DUKE POWER COMPANY - OCONEE NUCLEAR STATION 1 DOCKET  
NO. 50-269

DUKE POWER COMPANY - OCONEE NUCLEAR STATION  
DOCKET NO. 50-269  
TECHNICAL SPECIFICATION - OPERATING LIMITS

Figure 15 - 3  
 10/1/70

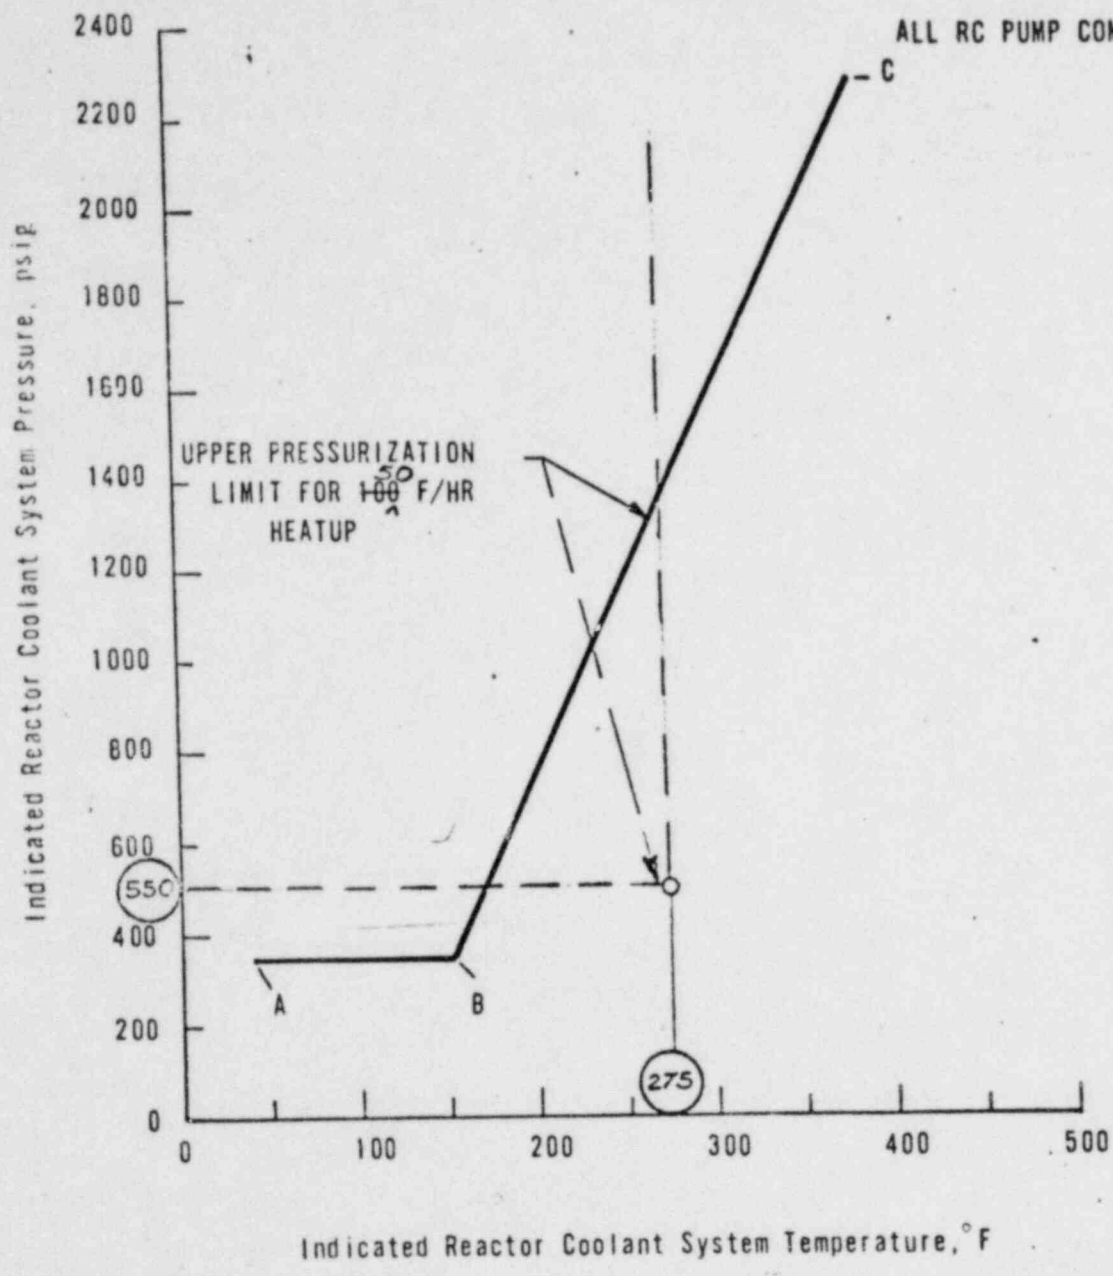
1. For the first two years, the Oconee 1 reactor coolant system should be operated and hydrotested in such a manner that at temperatures below 275°F, (a) the pressure does not exceed 550 psig (i.e., 25 percent of the normal operating pressure), and (b) the rate of temperature change does not exceed 50°F/hr.

2. Full pressurization of the reactor coolant system is acceptable during the first two years at temperatures above 275°F.

The above limits should be used as a basis for the Technical Specifications for the Oconee Plants and are shown in a dashed line on the attached figure. Our proposed operating limits are intended to apply to both heatup and cooldown procedures.
